Project	IEEE 802.16 Broadband Wireless Access Working Group < http://ieee802.org/16 >	
Title	Illustration of the frame structure for a 16m TDD system with four switching points	
Date Submitted	2008-05-13	
Source(s)	Per Ernstrom, Per-Erik Östling Ericsson AB SE-164 80 Stockholm, Sweden Lei Wang Nextwave Wireless	E-mail: Per.Ernstrom@ericsson.com, Per-Erik.Ostling@ericsson.com Lwang@nextwave.com
Re:	The call for contributions on “The entire content of IEEE 802.16m-08/003r1” (Frame structure)	
Abstract	Multiple sections of the documents contain text proposals in support of comment submitted separately on the proposed frame structure baseline content in document C802.16m-08/118r1.	
Purpose	Propose text changes to the SDD in support of a comment to IEEE 802.16m-08/003r1 (SDD) submitted separately	
Notice	<i>This document does not represent the agreed views of the IEEE 802.16 Working Group or any of its subgroups. It represents only the views of the participants listed in the “Source(s)” field above. It is offered as a basis for discussion. It is not binding on the contributor(s), who reserve(s) the right to add, amend or withdraw material contained herein.</i>

Illustration of the frame

Figure X Example of sub-frame configuration in TDD duplex scheme with four switching points per radio frame (CP=1/8 Tu).

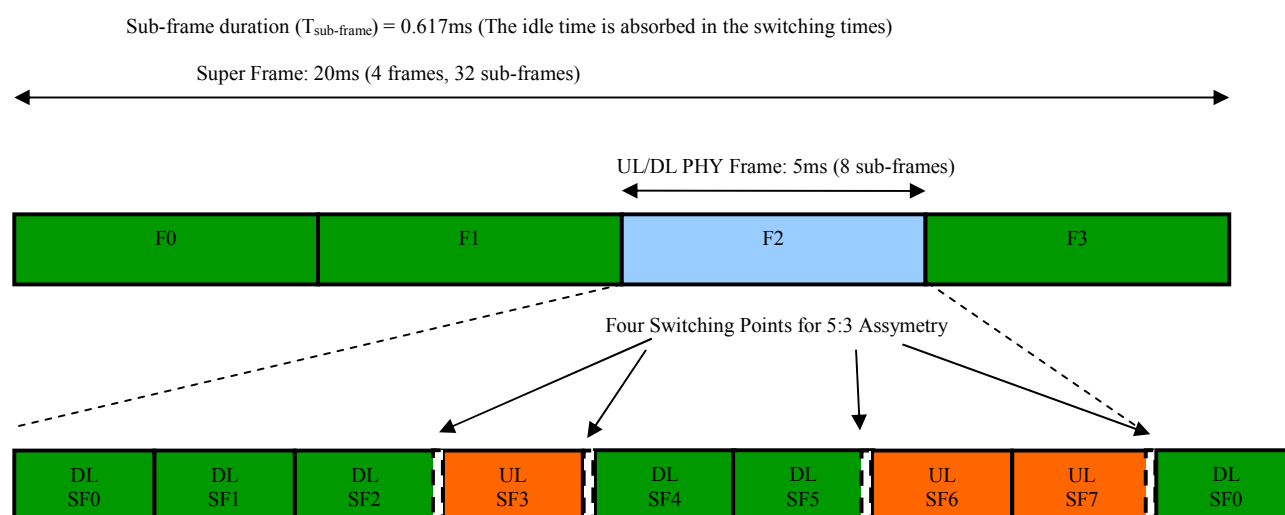
In the SDD (802.16m-08/003r1), in section 11.4.1 on the Basic Frame Structure, it is stated that the number of switching points in each radio frame is between two and four for TDD systems. There is, however, no illustration of the four switching point case. We believe that such an illustration would be helpful for further work, and propose therefore the introduction of such a figure, and associated text.

Change the paragraph in line 23 to 27 on page 17 as follows:

Figure 9 and figure X illustrates ~~an~~ example TDD frame structures with DL to UL ratio of 5:3, for two and four switching points respectively. Assuming OFDMA symbol duration of 102.82 us and a CP length of 1/8 Tu, the length of regular and irregular sub-frames are 0.617 ms and 0.514 ms, respectively. Other numerologies may result in different number of sub-frames per frame and symbols within the sub-frames. Figure 10 shows the frame structure in FDD mode.
